## Comments

In D3.1 we add the following functionality, and after simulating some parts and analyzing the changes we did, we found some errors in state machine and variable definitions that need to be corrected.

#### 2. change the following state machine for the primary and secondary as shown for the primary.

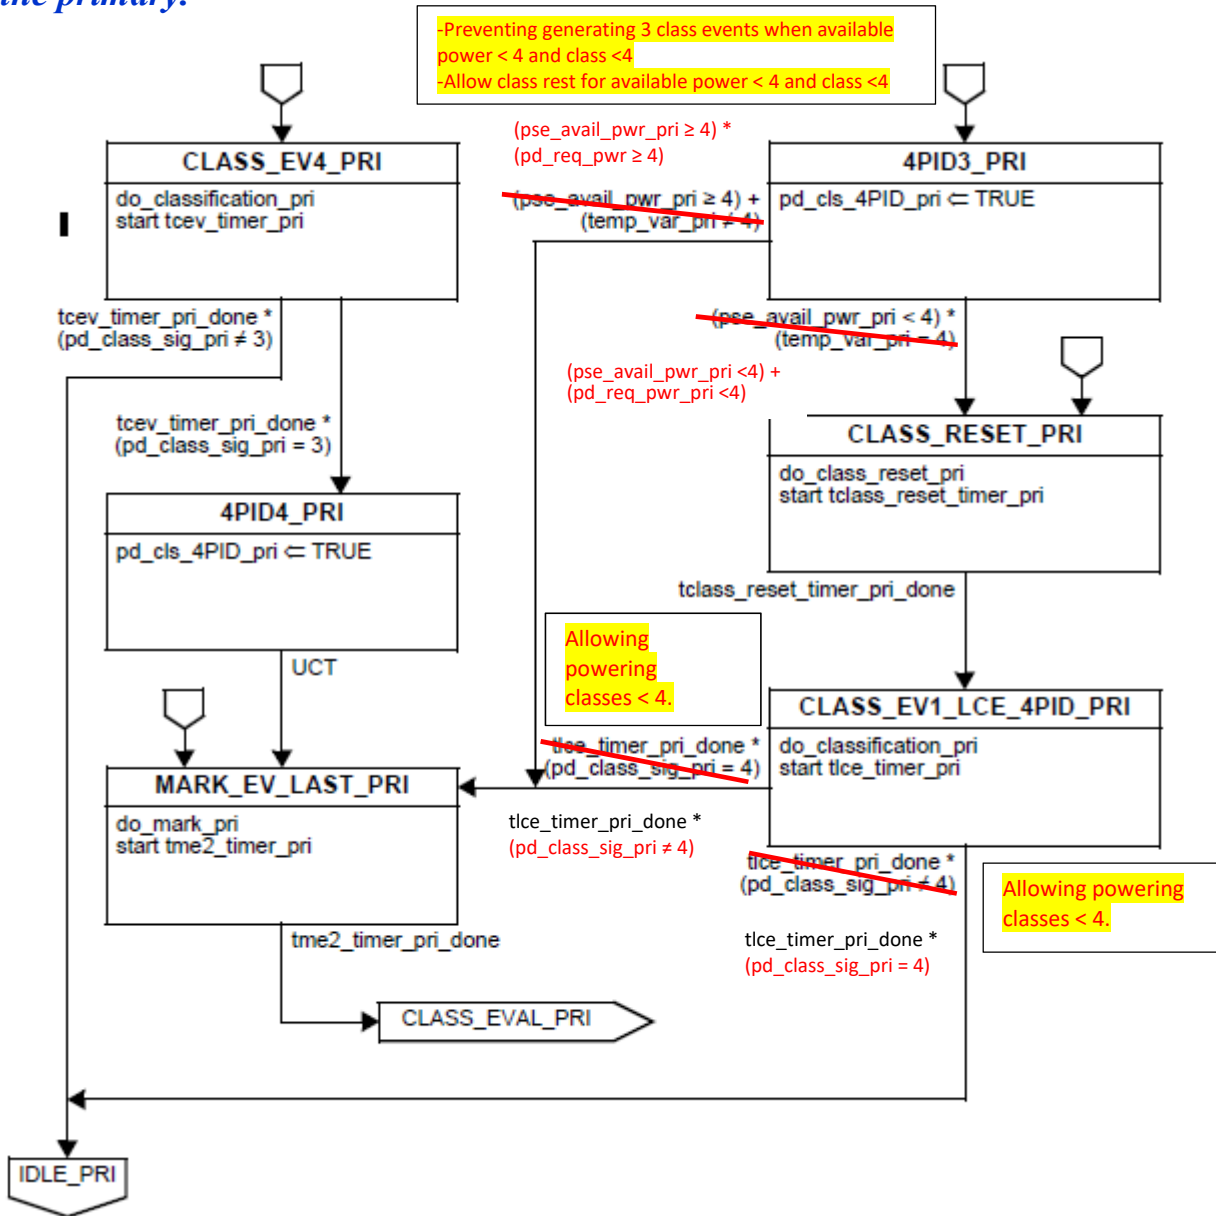
- d) The exits from 4PID3\_PRI to CLASS\_RESET\_PRI and MARK\_EV\_LAST\_PRI are incorrect and creates a scenario that when pse\_avail\_pwr\_pri < 4 and the pd\_req\_class\_pri < 3, the PSE generates 3 class events on the way to MARK\_EV\_LAST\_PRI instead of doing class reset, generate long class event and then go to MARK\_EV\_LAST\_PRI as required. [See details in Annex B.](#)

- e) The intent when doing CLASS\_PROBE\_PRI with 3 short class events when pse\_avail\_pwr\_pri < 4 was to go to class reset and then to single long class event and then power up. Now in D3.1, If option\_class\_probe is set, state machine will either go to IDLE\_PRI or to CLASS\_RESET\_PRI and from CLASS\_RESET\_PRI eventually to IDLE\_PRI instead of continuing towards MARK\_EV\_LAST\_PRI and powering the port while allowing powering with only single long class event and not twice. [This is not working. See Annex C for details.](#)

In the exit from 4PID3\_PRI to CLASS\_RESET\_PRI:

1. Change from (pse\_avail\_pwr\_pri < 4) \* (temp\_var\_pri = 4)

(pse\_avail\_pwr\_pri < 4) + (pd\_req\_pwr\_pri < 4)

2. In the exit from 4PID3\_PRI to MARK\_EV\_LAST\_PRI change from:

(pse\_avail\_pwr\_pri ≥ 4) + (temp\_var\_pri ≠ 4)

(pse\_avail\_pwr\_pri ≥ 4) \* (pd\_req\_pwr ≥ 4)

**1. Change the exit from `CLASS_EV1_LCE_4PID_PRI` to `MARK_EV_LAST_PRI` from:**

`tlce_timer_pri_done * (pd_class_sig_pri = 4)` to: `tlce_timer_pri_done * (pd_class_sig_pri  $\neq$  4)`

**2. Change the exit from `CLASS_EV1_LCE_4PID_PRI` to `IDLE_PRI` from:**

`tlce_timer_pri_done * (pd_class_sig_pri = 4)` to: `tlce_timer_pri_done * (pd_class_sig_pri = 4)`.

4. change the following state machine for the primary.

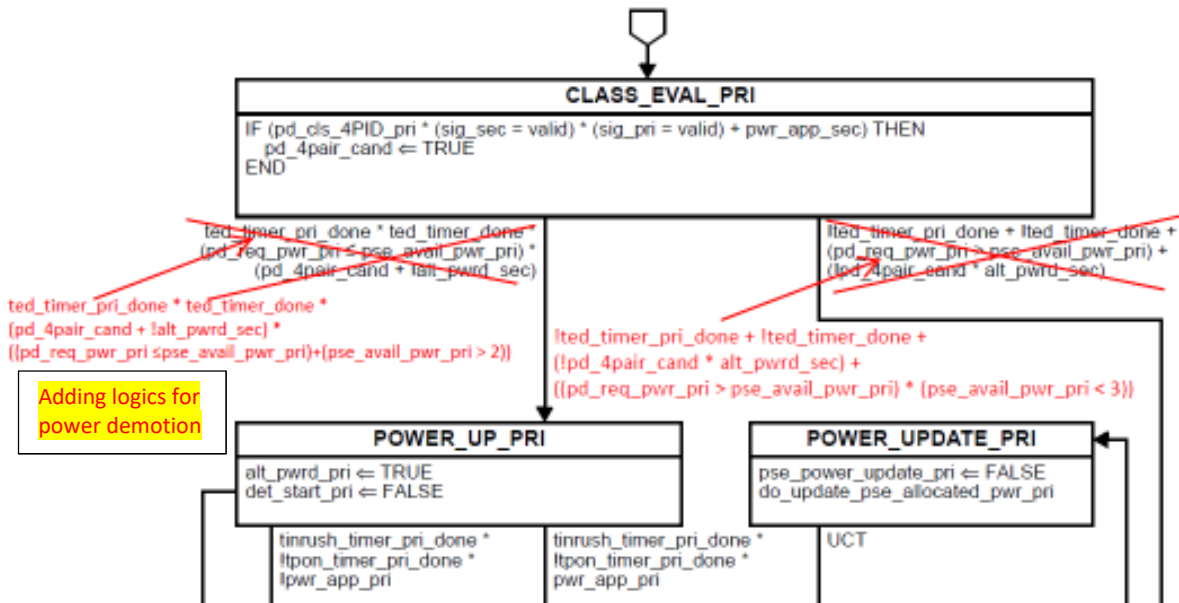
- f) Missing logic for power demotion in the exits from CLASS\_EVAL\_PRI (and CLASS\_EVAL\_PRI). [See Annex D.](#)
- g) All the above issues are the same for the secondary as well.

**1. Change the exit from `CLASS_EVAL_PRI` to `POWER_DENIED_PRI` from:**

`!ted_timer_pri_done + !ted_timer_done + (pd_req_pwr_pri > pse_avail_pwr_pri) + (!pd_4pair_cand * alt_pwr_sec)`

`!ted_timer_pri_done + !ted_timer_done +  
(!pd_4pair_cand * alt_pwr_sec) +  
((pd_req_pwr_pri > pse_avail_pwr_pri) * (pse_avail_pwr_pri < 3))`

**2. Change the exit from `CLASS_EVAL_PRI` to `POWER_UP_PRI` from:**

`ted_timer_pri_done * ted_timer_done * (pd_req_pwr_pri  $\leq$  pse_avail_pwr_pri) * (pd_4pair_cand + !alt_pwr_sec)`

`ted_timer_pri_done * ted_timer_done *  
(pd_4pair_cand + !alt_pwr_sec) * ((pd_req_pwr_pri  $\leq$  pse_avail_pwr_pri) + (pse_avail_pwr_pri > 2))`
